Council Members' Briefing Session

Briefing Papers for Tuesday, 3 September 2024

6.1 Consideration of Precinct 15 - Central Mariginiup Local Structure Plan Following Advertising

To consider the proposed Precinct 15 – Central Mariginiup Local Structure Plan (**LSP**) and forward its recommendation to the Western Australian Planning Commission (**WAPC**) for assessment and determination.

Figure 19 - Illustrative Master Plan (Source: Emerge)

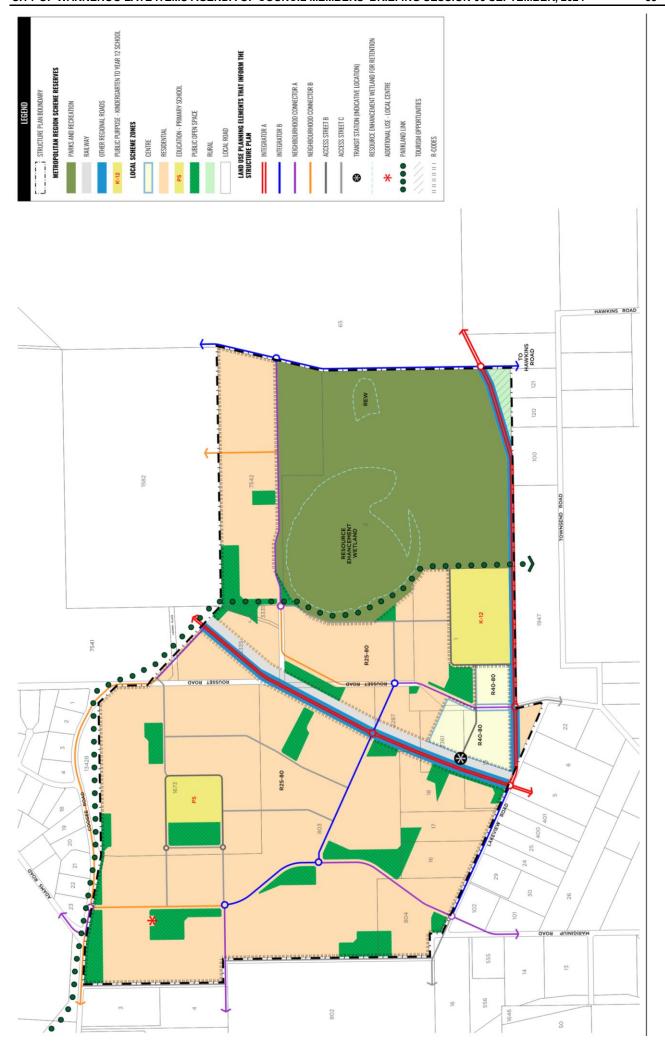
7.5	However, there is a spatial separation between the site and the neighbourhood centre by a park and ride or medium density housing. Additionally, there is an inconsistency in Figures 18 and 19 in terms of the way in which this area offering spatial separation between the K-12 school site and the Neighbourhood centre.	Noted. This inconsistency will be addressed.	The park and ride facility represented in Figure 19 is a representation of a location in which parking will be developed. In accordance with the requirements of the EWDSP, a parking strategy is required to be developed to address parking associated with the neighbourhood centre and the transit stop. Given that this information has not been provided, Administration recommends as a schedule of modification that additional text is included in Part 1 of the LSP that requires a parking strategy to be lodged for approval prior to the development and subdivision of the neighbourhood centre. Inconsistencies between Figure 18 and 19 will be reviewed and corrected in the LSP.	It is recommended that a parking strategy is developed for the neighbourhood centre prior to the subdivision and development of the centre.

7.8	Based upon Figure 19 – Indicative Master Plan in Structure Plan Report and Landscape Masterplan, the indicative overlay of the oval in 'POS 9' identifies that half of the oval sits within the effective primary school site. It should be highlighted that a maximum area of encroachment of the overall including over-runs into the school site is 0.5 hectares.	Requirement noted. This plan is indicative only. This is detailed design for future stages of planning of this POS and primary school.	Noted. Administration is not supportive of any portion of the oval being partially located within the Department of Education Primary School. Administration requires that the co-located oval is a minimum of 4.5 hectares in size to accommodate a full size oval entirely within the site and the associated neighbourhood pavilion/local community centre. The provision of this community facility is in accordance with the City of Wanneroo's endorsed Community Facilities Plan.	It is recommended that POS 9 is increased in area to a minimum of 4.5 hectares in area so as to accommodate the neighbourhood oval and local pavilion/community centre.

Figure 22 - Road Hierarchy (Source: Transcore)

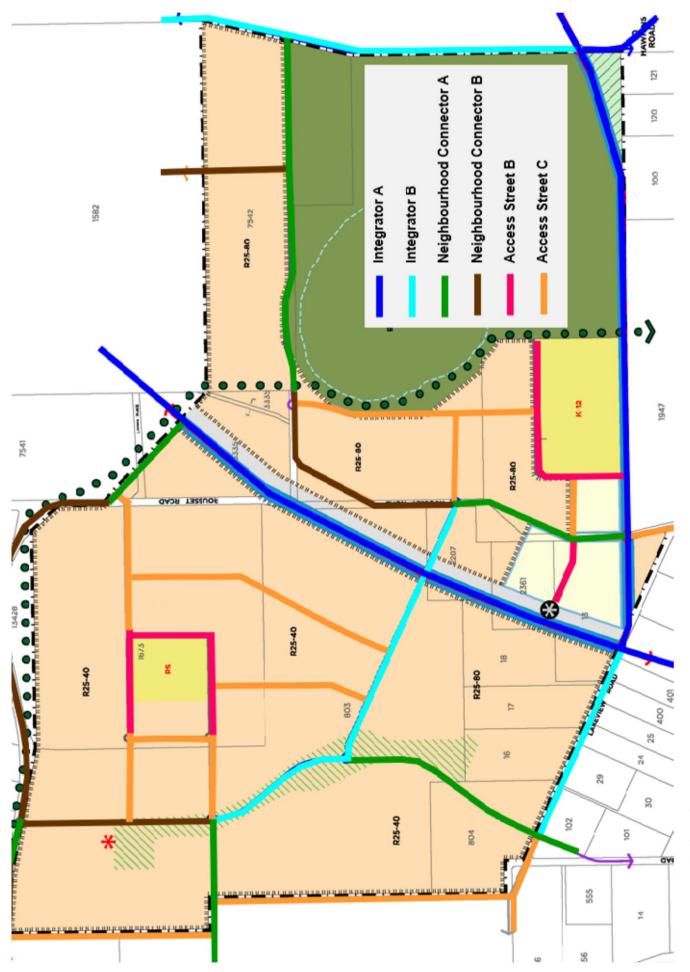
The proposed hierarchy of roads in and around Precinct 15 is illustrated in **Figure 22**. The classification of roads is based on preliminary analysis of future traffic flows provided within the TIA (refer **Appendix 7**).

Figure 15: Post-development surface water drainage

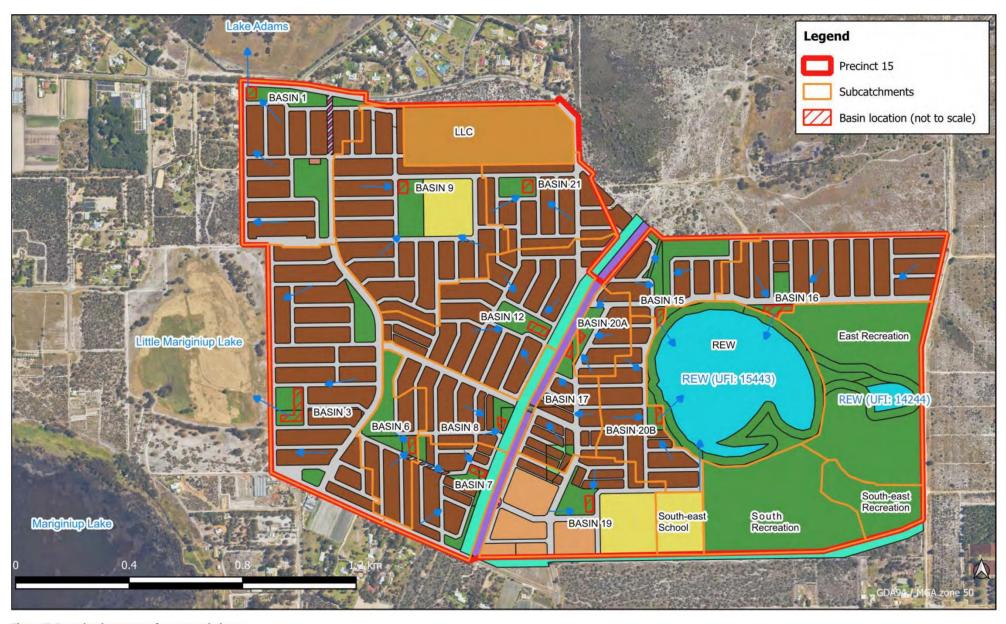
7.9	Concern is also raised that both school locations are currently proposed on existing wetlands. Additionally, Figure 15 of the Post Development Surface Drainage of the LWMS and Appendix D of the Engineering Report seek possible allocation of a drainage basin and pump station on POS 9. Further, a pump station is also identified on the K-12 school site.	These are Multiple Use Wetlands, not required to be protected and not proposed to be retained. As such, these sites will be earthworked to support development and the school sites (physical site requirements) will be delivered in accordance with OP2.4.	Noted. In accordance with the Proponent's comments, the proposed school sites will be required to be earthworked to accommodate development. Administration recommends as part of its resolution that prior to the approval of the LSP that the DoE is further consulted to confirm the sufficiency of the school sites proposed.	It is recommended that as part of the resolution, that prior to the adoption of the LSP that further consultation is undertaken with DoE to confirm the sufficiency of the education sites.
